TITLE: CHANGE OF ZONE NO. 04075F
(Village Gardens PUD - AG to R-3 -
South 63rd Street and Yankee Hill Road)

LINCOLN/LANCASTER COUNTY PLANNING STAFF REPORT

PROJECT #: Annexation #15006
Change of Zone #04075F - Village Gardens Planned Unit Development (PUD)

PHASE 2 - PLANNED UNIT DEVELOPMENT
SITE PLAN

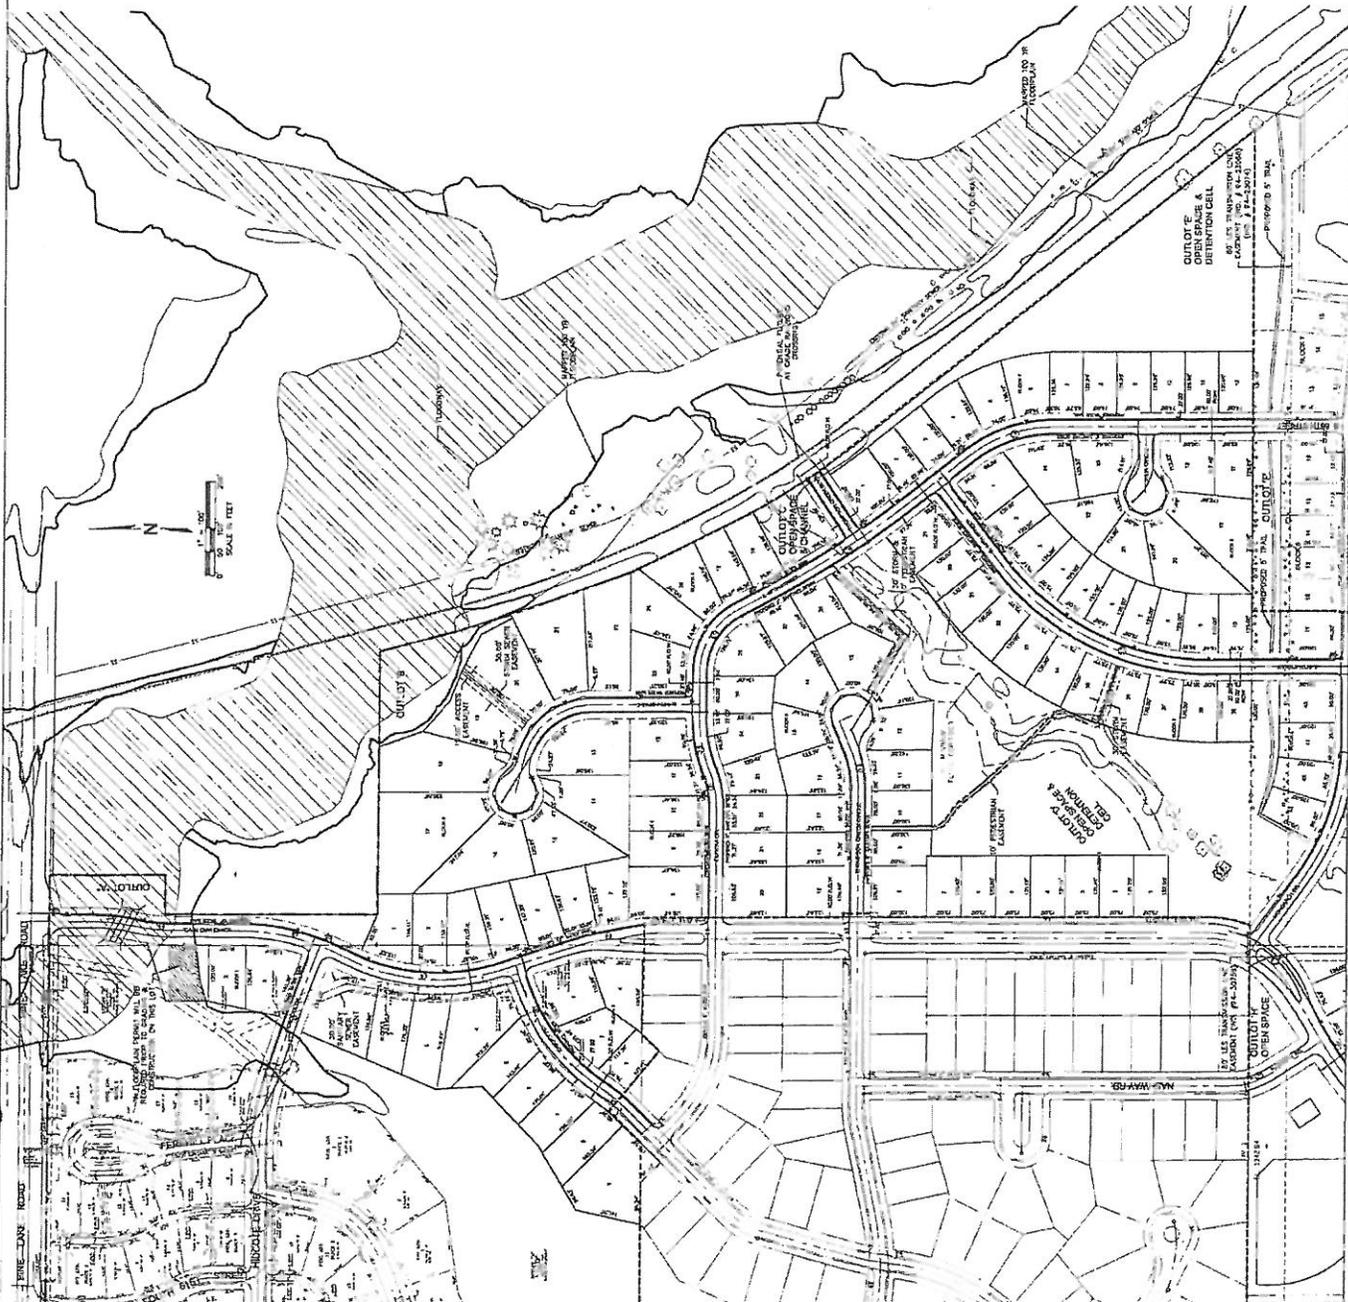
5. In their review the Health Department noted the existence of a natural gas pipeline located in the Yankee Hill Road right-of-way. Using a Federal Government formula the Health Department calculated that the PPA extends 221' on either side of the pipeline. The location of the 221' hazard area is shown on Sheet 3 of 11 of the plan set and illustrates the impact upon this development.

Portions of Lots 11-19, Block 22 are within the PPA. It is likely dwellings can be built on Lots 11 and 19 outside the PPA. However, that is probably not the case with Lots 12-18, as the lots are too small to accommodate dwellings built entirely outside the PPA. It could be made clear by defining building envelopes on those lots affected by the PPA, where the entire building envelope is outside the PPA.

6. A block length waiver is requested for Blocks 7, 22 and 23. Block 7 is adjacent to a railroad track, and because of this manmade feature is an allowed exception to the 1,320' maximum block length. However, blocks 22 and 23 are not adjacent to any natural or manmade feature that prohibits a street connection to South 67th Street. The application notes the area adjacent to Block 22 may be developed commercially. However, there is nothing unique about a residential area having access to a commercial area, and that condition exists in both older and newer areas all around the city today.

7. Pedestrian sidewalks are also required for any block over 1,000' in length. There are several blocks where the sidewalks are required but not shown in apparent oversight, but must be added to the site plan. The grading plan also must be revised if required to ensure all pedestrian sidewalks comply the applicable ADA requirements.

8. Regarding the area adjacent to Block 22 which is noted as intended for commercial uses. That label should be expanded to include apartments. This will allow more flexibility regarding future land use, and will give potential neighbor more advance notice that either apartments or commercial development could occur on the site.

- 2.1 Update the plan to include the information resulting from the approval of CZ#04075E and subsequent administrative amendment AA#14054.
 - 2.2 Revise the lot layout for Blocks 22 and 23 to show a building envelope for Lots 12-19 so no portion of the buildable area is shown within 200 feet of the gas line~~the PPA~~.

- 2.3 Label the roadways in Blocks 22 and 23 as private roadways.
 - ~~2.4 Show a street connection from Village Court to South 67th Street.~~
 - 2.5 Propose substitute street names as Village Court and Village Lane are already in use.

- 2.6 Also provide a dimension from the Yankee Hill Road right-of-way to the 20024' PPA.
 - 2.7 Label the area east of Block 22 as 'Future Apartment or Commercial Area'.

- 2.8 Renumber blocks to include Blocks 21 and 24.
 - 2.9 Show pedestrian sidewalks in blocks 11 ~~in excess of 1,000'~~ as required to the satisfaction of the Planning Department.

- 2.10 Revise the grading and drainage plans to the satisfaction of Public Works and Utilities. Grading plan also needs to demonstrate that all pedestrian connection sidewalks comply with ADA requirements.
